TRANSMITTAL COVER SHEET

DATE: 21 June, 2024
TO: ALL PLAN HOLDERS OF RECORD
FROM: HUNTER SWATEK, AIA, PROJECT MANAGER
PROJECT: RAINBOW CITY RECREATION CENTER
GMC PROJECT NO. ABHM230021
RE: ADDENDUM NO. 3 AND
ACKNOWLEDGEMENT OF RECEIPT OF ADDENDUM NO. 3

ADDENDUM NUMBER 03

**PROJECT: RAINBOW CITY RECREATION CENTER
GM&C PROJECT NO. ABHM230021**

C9 SOUTH
SCALE: 1/4"=1'-0"

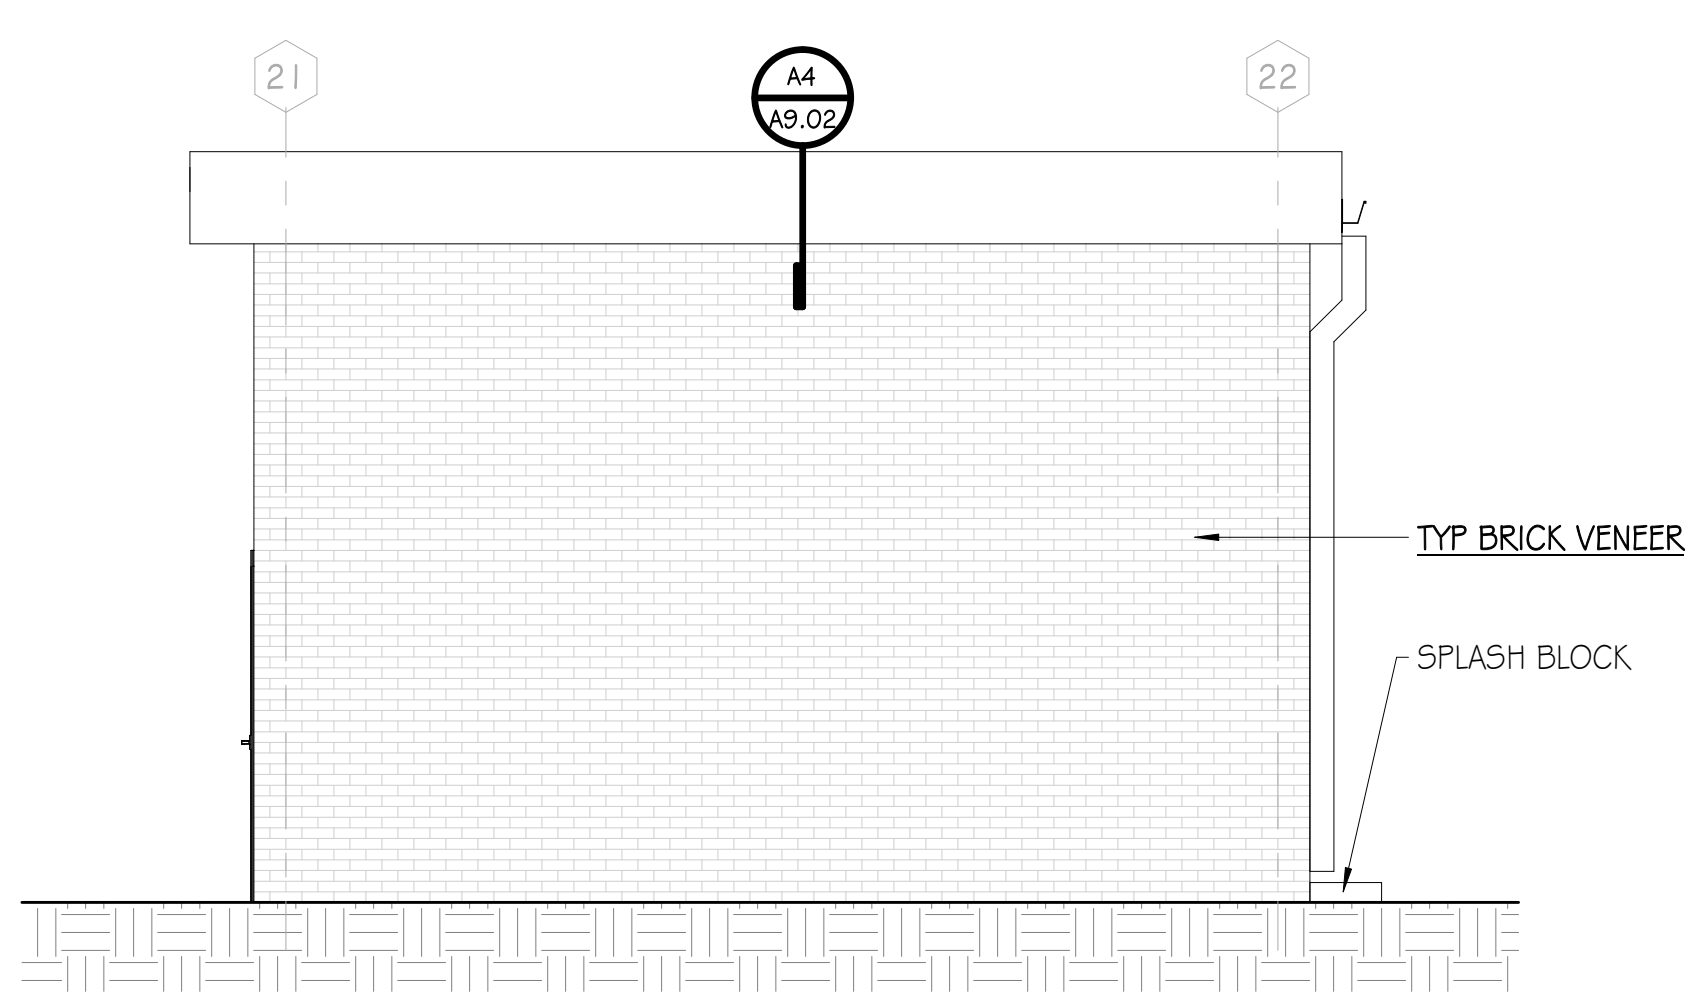
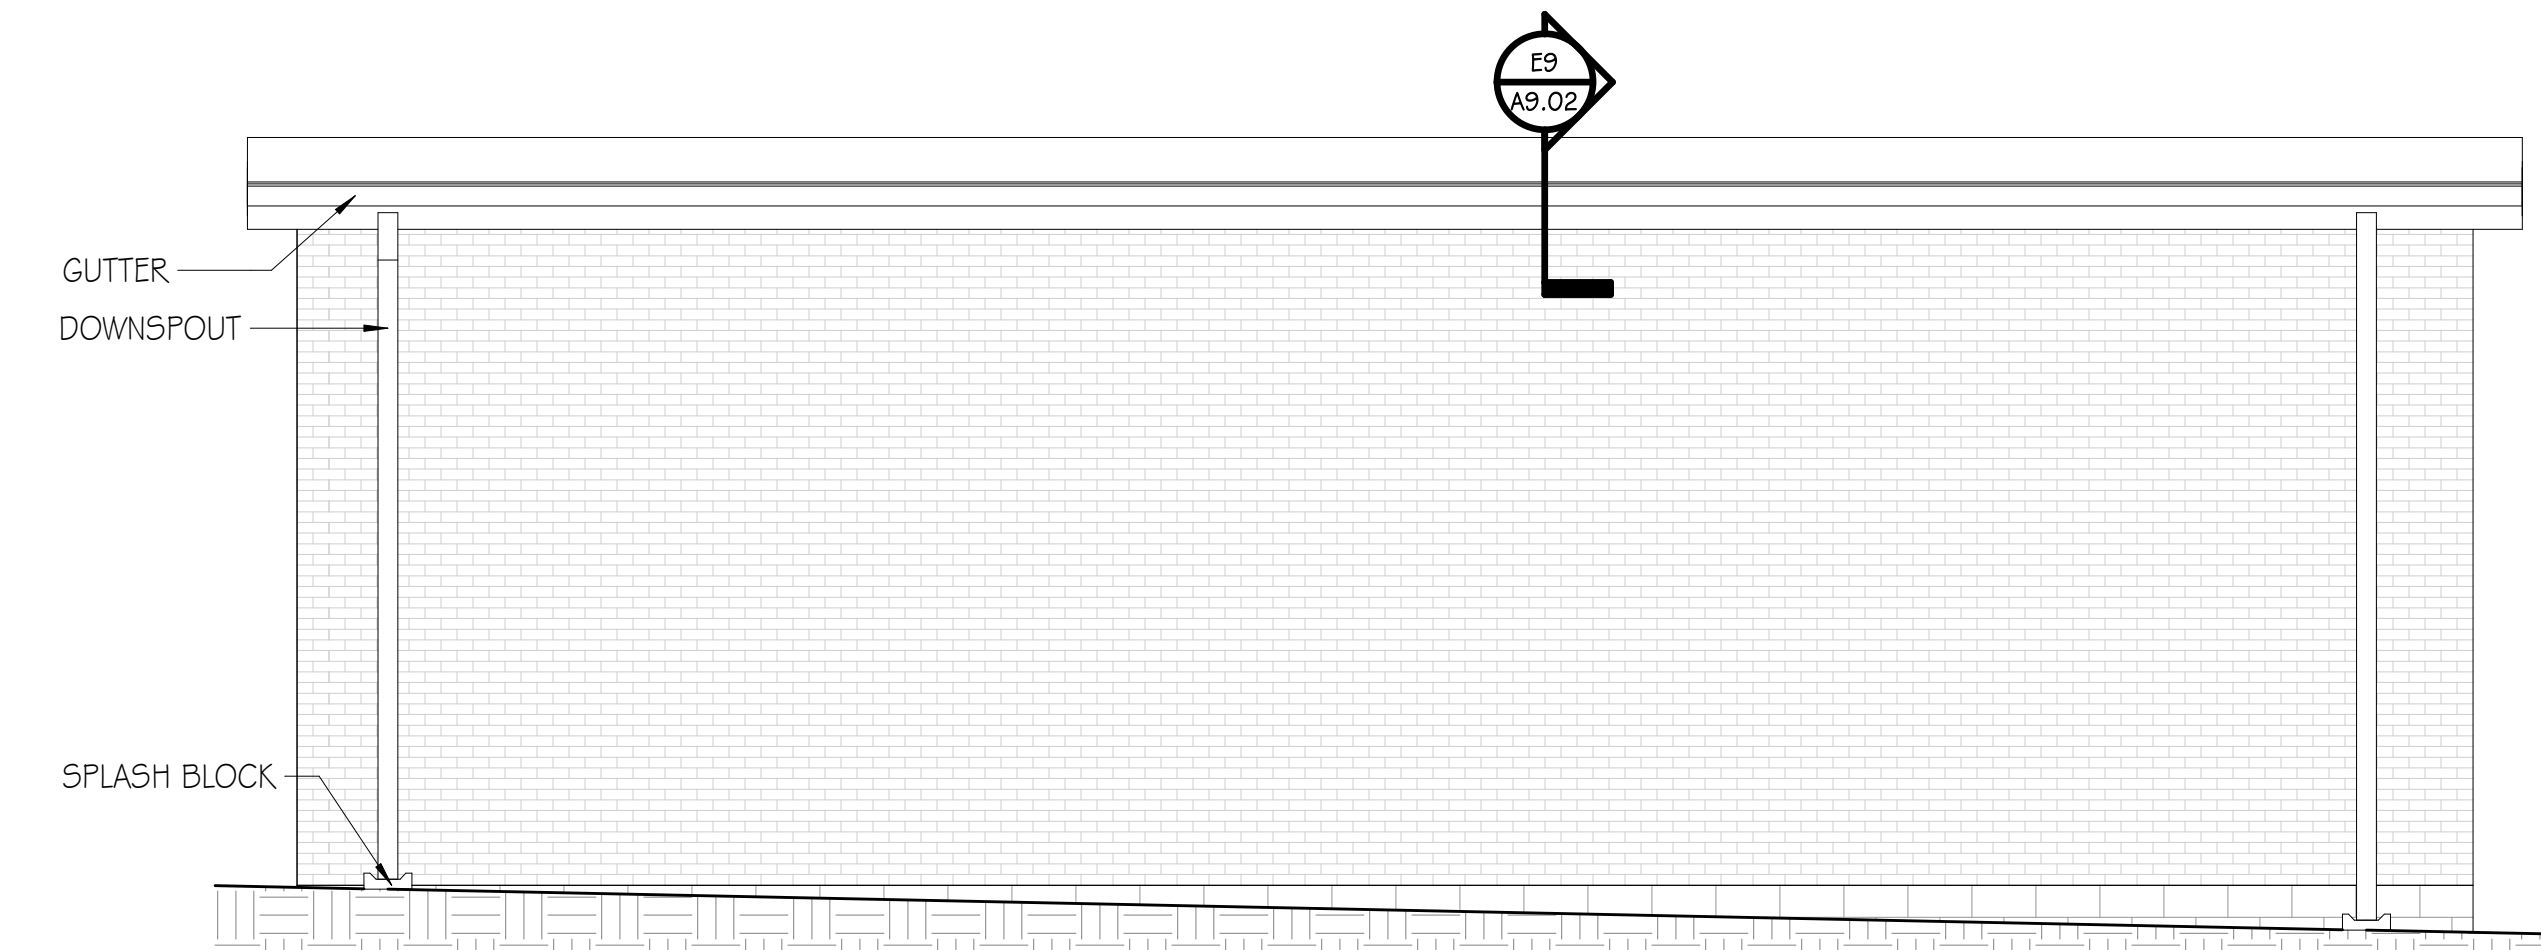
- A. **A2.01** – Reflected Ceiling Plan – Level 1
 - a. REVISED Concessions and Catering ceiling type
- B. **A9.01** - Pool Equipment Building
 - a. REVISED sheet drawings
 - b. ADJUSTED structural overhang depth in RCP
- C. **A9.02** - Pool Equipment Building Sections & Details
 - a. CREATED new sheet with roof details
- D. **A9.03** - Dumpster Enclosure
 - a. CREATED new sheet with plan, sections and details
- E. **A9.04** – Amphitheatre
 - a. REVISED sheet
- F. **C-101** – Site Layout Plan
 - a. ADDED Pool Collector Tank location
 - b. ADDED Wheel stops at parking adjacent to pool
 - c. REVISED Dumpster pad enclosure
- G. **C-102** – Alternate Site Layout Plan
 - a. REVISED Notes
 - b. REVISED Playground
- H. **C-201** – Grading Plan
 - a. REVISED grading around pool house and playground
- I. **C-202** – Alternate Grading Plan
